UR Family

Version 7.1x

Release Notes

This document contains the release notes for firmware and software versions 7.10, 7.11, and 7.12 of the Universal Relay (UR) family of products.

Illustration of in-zone transformer for two and three terminal lines

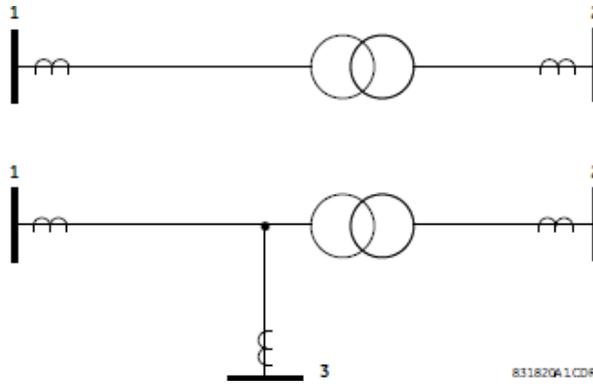
N L90 Line Current Differential element has been enhanced to support the “In-zone” power transformer functionality

Description: Firmware version 7.10 improves the L90’s protection capabilities by enabling the L90 to fit two and three terminal line differential schemes that have a power transformer within the protection zone with no dedicated set of CTs.

The new functionality provides internal magnitude and angle compensation plus magnetizing inrush inhibition capabilities that maintain the line differential protection selectivity. Magnitude values are compensated using the existing CT Taps setting fields. However, in order to compensate for current phase-shift caused by the transformer connection group and magnetizing inrush current, new setting fields have been added to the existing “87L Power System” and “Current Differential” elements.

With firmware 7.10, both L30 and L90 devices share the same “In-zone transformer” functionality and software options. L90 devices that are equipped with the new In-zone transformer software option perform single terminal fault location only (no multiple terminal fault location).
